RESPONSE TO AN BORD PLEANÁLA OPINION

St Kevin's Strategic Housing Development (SHD)

at the former St. Kevin's Hospital and Grounds, Shanakiel, Cork

Ref: ABP-307259-20

Figure 3.2 – Extract of diagram explaining access location for duplex units, included in the *Design Statement*, prepared by Reddy Architecture + Urbanism [Cropped by TPA, 2020]

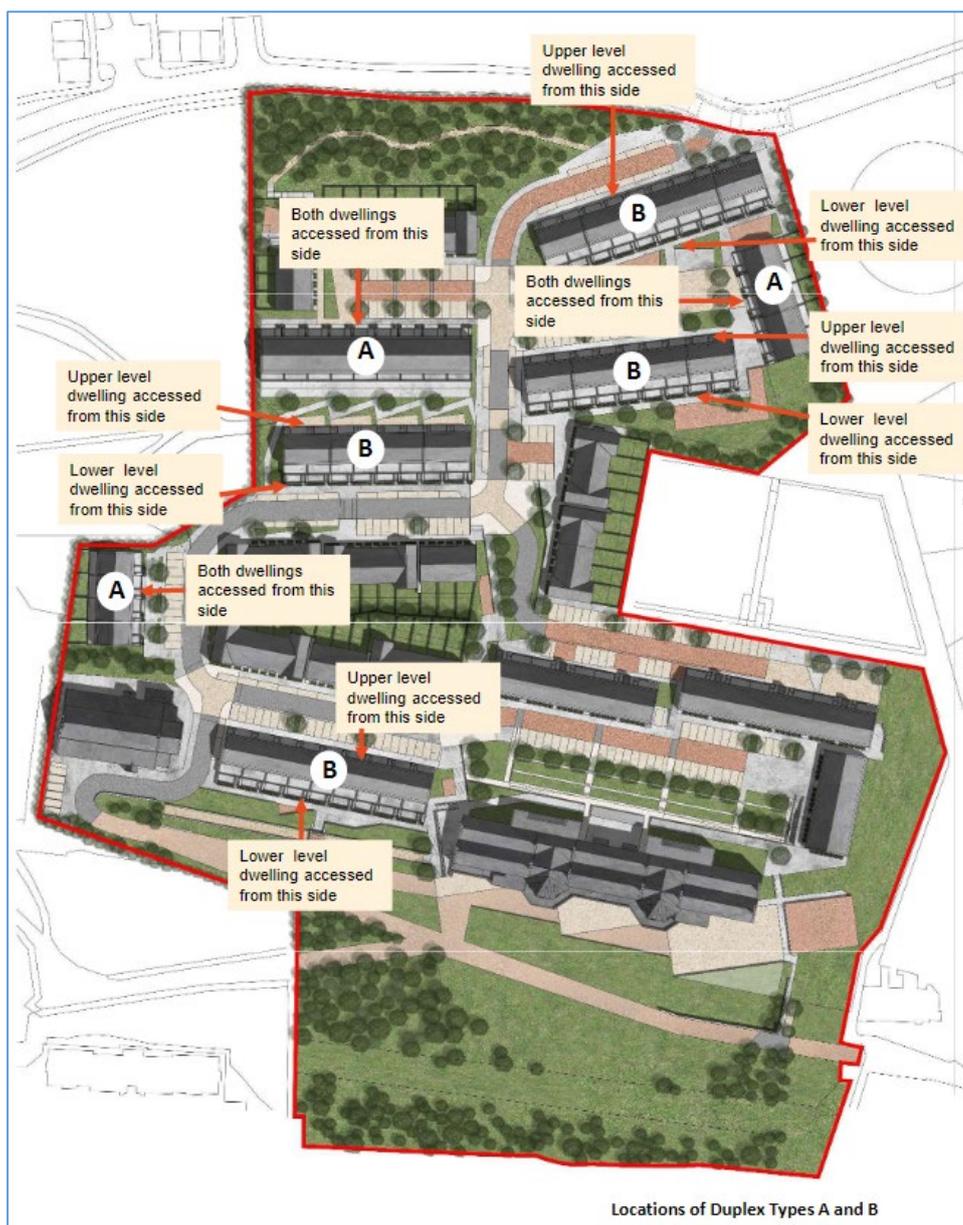
- *The inclusion of appropriate pedestrian and cycle connections into adjoining sites indicating enhanced permeability.*
- *The design and layout of the duplex units to ensure clarity on the functioning and entrance into the units with regard to any double fronted units provided, the appropriate public realm to ensure strong streetscapes are created in conjunction with the proposed pedestrian/ cyclist movement through the site.”*

In relation to the interaction between the Duplex units and the adjoining public realm, the *Response* outlines

“There are two types of Duplex A and B. Duplex A is a typology whereby both dwellings are accessed from the same side and Duplex B is a typology whereby each dwelling is accessed from opposite sides at different levels. Duplex A is a more conventional duplex arrangement suitable for level sites, Duplex B is specifically designed to deal with the steeply sloping topography of this site.

The duplex units are located throughout the site and are accessed directly from homezones including a landscaped path between blocks D and E.

Block E is a Duplex Type B with the upper dwelling accessed directly by means of bridges from the landscape path, whereas the lower dwelling is accessed at street level below. Block D is not accessed from the landscape path, both dwellings are accessed from Home Zone 1 above.

By these arrangements we are provided active edges to both sides of the duplex units reinforcing the streetscape while providing privacy by means of setback planters, terraces and changes in level.”

Figure 3.3 – Extract of diagram proximity to public bus routes, included in the *Traffic and Transport Assessment and Mobility Management Plan*, prepared by ILTP Consulting. [Cropped by TPA, 2020]

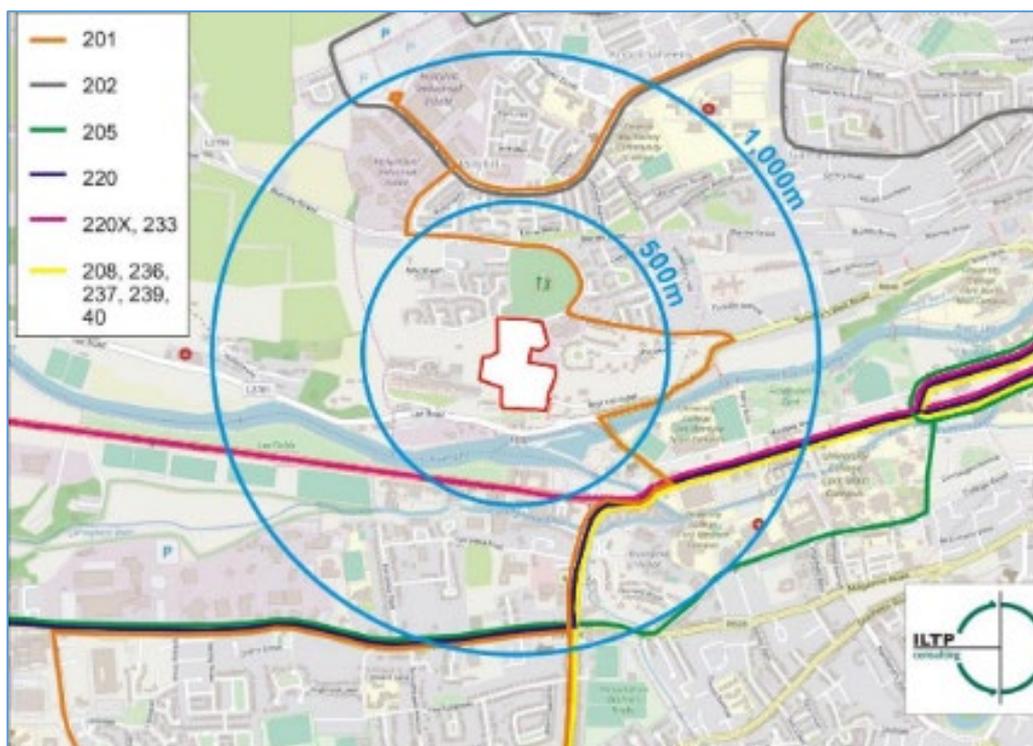
- *The quantum of car parking provided within the scheme having regard to the potential for dual use for the creche and enterprise centre, future proposed public transport schemes in the vicinity of the site and the requirement to promote sustainable transport patterns for new developments.*
- *The design and location of the car parking provision adjoining the apartment blocks, in particular Blocks S, T & U, the need for high quality public realm and landscaping and the visual impact on future residential occupants of these apartment blocks.”*

In addition, an assessment of the existing public transport network and methods for promotion of sustainable transport modes are provided in the *Traffic and Transport Assessment and Mobility Management Plan*, prepared by ILTP Consulting.

Figure 4.4 – Extract of Connectivity Diagram - *Design Statement*, prepared by Reddy Architecture + Urbanism [Cropped by TPA, 2020]

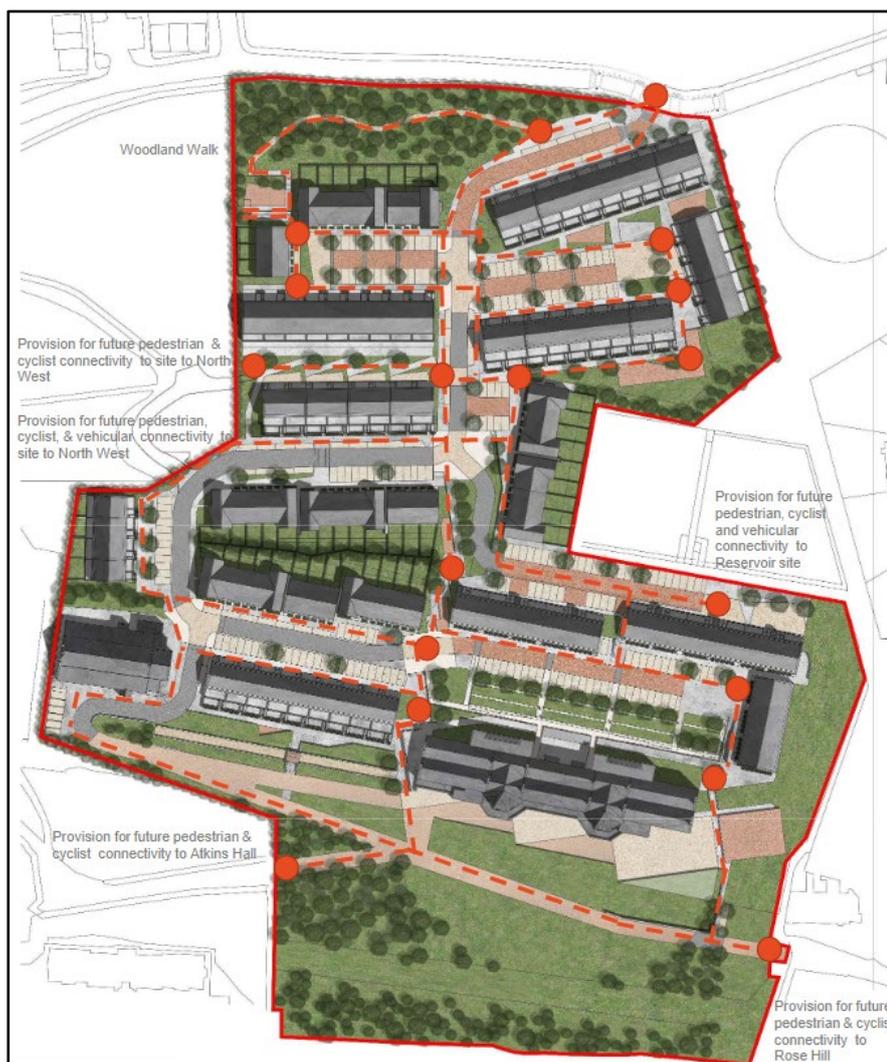
“Clarification and integration of pedestrian and cycle connectivity from the site into adjoining sites in the vicinity, in particular south east through Rose Hill Upper and south west through Atkins Hall apartment complex.”

As noted above, the proposed design makes provision for future connectivity to both Rose Hill Upper to the east and the adjoining Atkins Hall to the west, subject to agreement. The Applicant is agreeable to accepting a suitably worded condition of planning in this regard, such as;

This is also demonstrated on the *Pedestrian and Cyclist Accessibility and Connectivity Plan Layout* (No. 19305-BMD-ZZ-XX-DR-C-1051) shows the routes through the site and the connection points with adjoining sites.

Figure 4.7 – Extract of *Landscape Framework Plan* (DWG No. 60619639-SHT-20-L-1000), prepared by Aecom [Cropped by TPA, 2020]

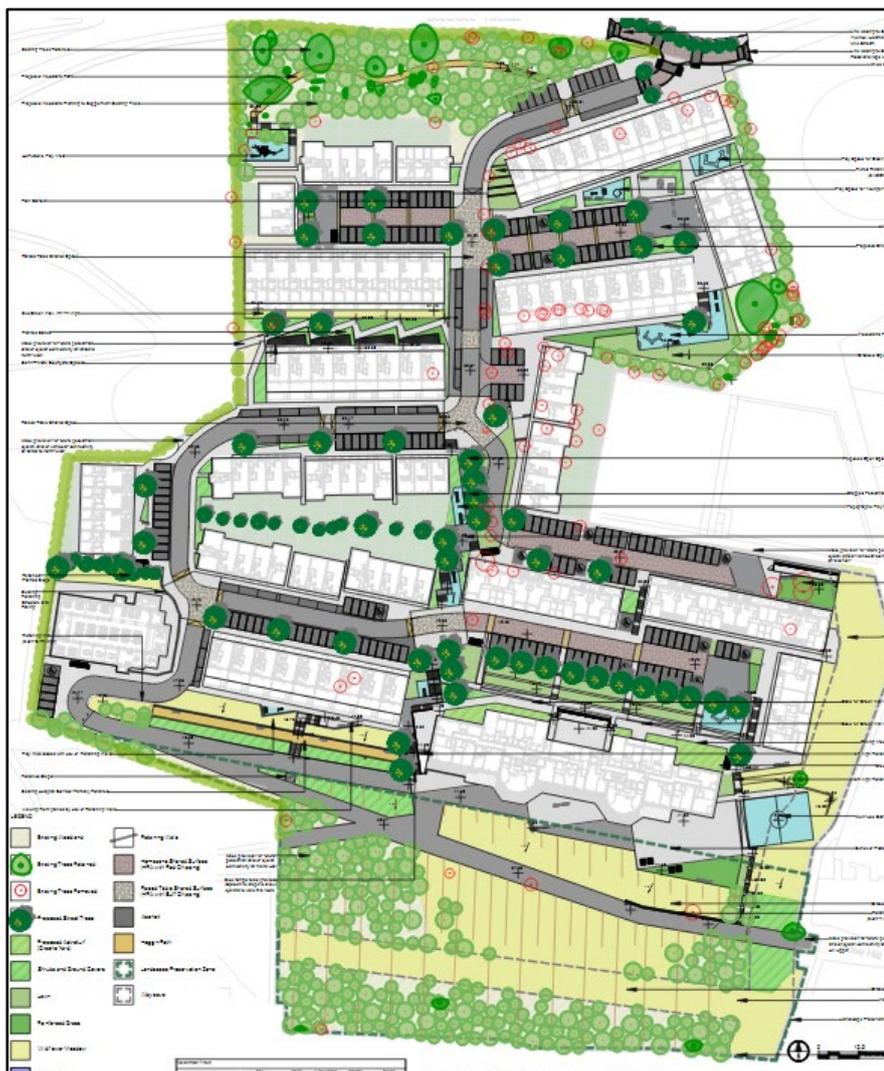
“Updated Landscape Master plan detailing the functionality of all passive and active play facilities including, inter alia, overlooking and surveillance of active play areas, detailed plans for the future use of the open space within the Landscape Protection Zone and compliance with the requirement for play facilities as per Section 4.13 of the Sustainable Urban Housing: Design Standards for New Apartments Guidelines for Planning Authorities (2018).”

A *Landscape Framework Plan* (DWG No. 60619639-SHT-20-L-1000), has been prepared by Aecom, which should be read in conjunction with the enclosed *Landscape Architecture and Public Realm Design Report*.

The *Report* notes the proposed play areas all benefit from passive surveillance of adjoining blocks and compliance with Section 4.3 of the *Sustainable Urban Housing: Design Standards for New Apartments Guidelines for Planning Authorities (2018)*, regarding play facility requirements. The *Report* also outlines a precedent study and development of the design concept for the Landscape Protection Zone, as required. The *Report* notes;

Figure 4.12 – Extract of DWG No. 19305-BMD-ZZ-XX-DR-C-1050 'Phasing Strategy' prepared by Barrett Mahony Consulting Engineers [Cropped by TPA, 2020]

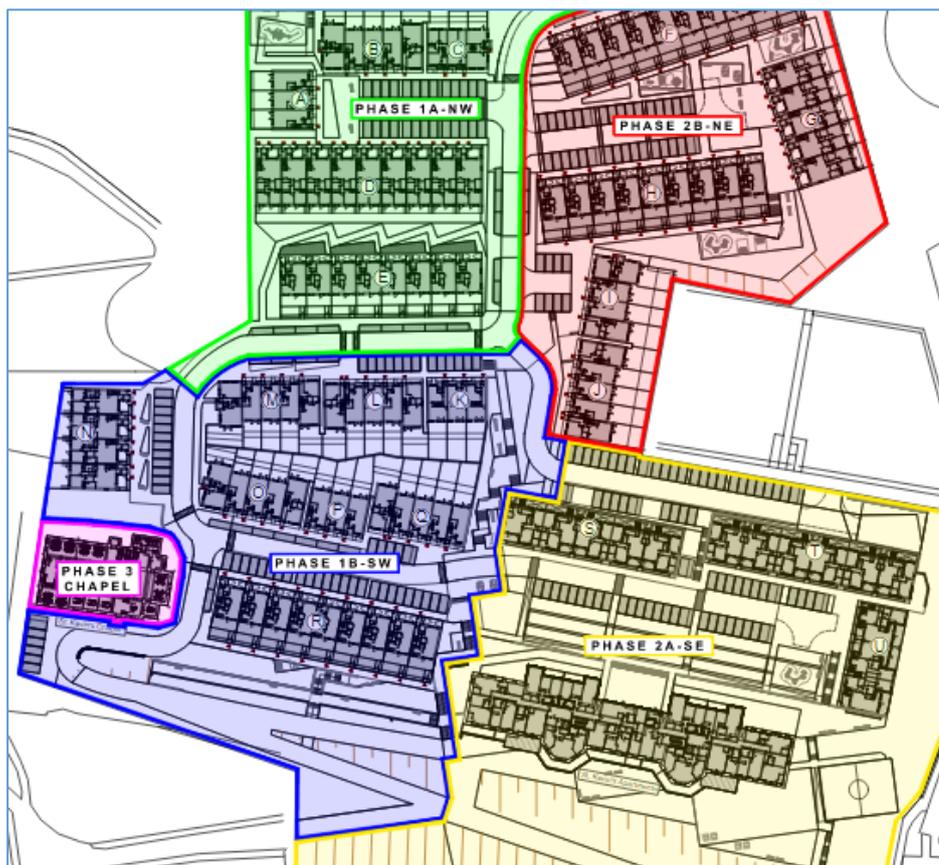
“A phasing plan for the proposed development which includes the phasing arrangements for the delivery of the public open spaces, surface water management proposals and Part V provision.”

A phasing plan and strategy (DWG No. 19305-BMD-ZZ-XX-DR-C-1050) prepared by Barrett Mahony Consulting Engineers is enclosed with the application. This drawing demonstrates that the proposed development is divided into a series of 5 no. phases (1A, 1B, 2A, 2B & 3.)

This is to allow for work to commence in the west (Phases 1A and B), remote from the Irish Water works (as approved under CCC Reg. Ref. 18/37965) along the eastern boundary of the site. This would allow both projects to proceed simultaneously if the timelines so dictated.

Figure 4.13 - Extract of DWG No. 60619639-SHT-20-L-0003, *Bat Protection*, prepared by Aecom [Cropped by TPA, 2020]

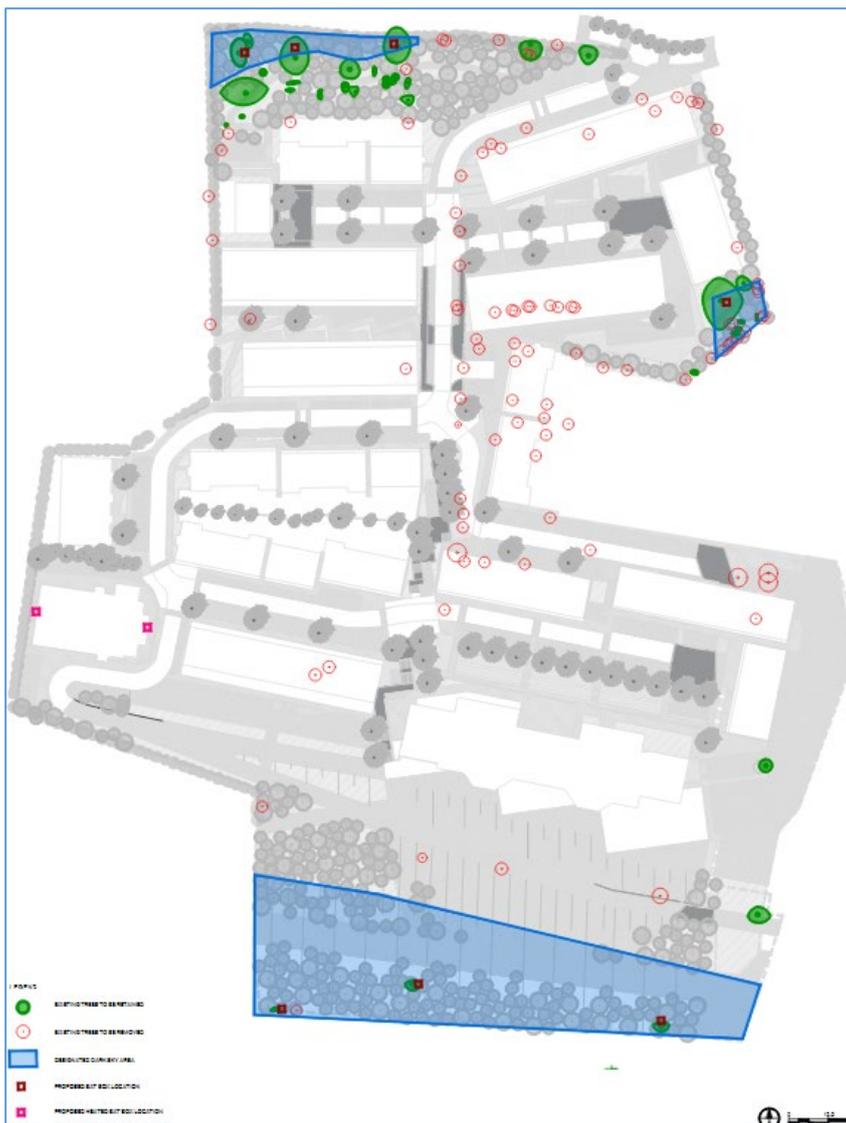
"Submission of a Breeding Bird Survey and a Bat Survey."

The *Bat Survey Report* confirms 5 no. Common Pipstrelle roosts, 2 no. Leisler's Bat roosts and 4 no. Soprano Pipistrelle roosts were noted on site over 2 no. season surveys. All roosts were of individuals or up to three bats, with no large maternity roosts found.

The *Report* recommends 11 no. measures to alleviate impact, which have been integrated into the proposed development accordingly. This includes dark sky provision, bat boxes and bat tubes, as well as public lighting recommendations. Associated landscape design alleviation measures are outlined in further detail in DWG No. 60619639-SHT-20-L-0003, *Bat Protection*, prepared by Aecom. In addition, the *Construction Environmental Management Plan*, prepared by O' Callaghan Moran confirms impact alleviation measures recommended by the project ecologist have been integrated into the plan.
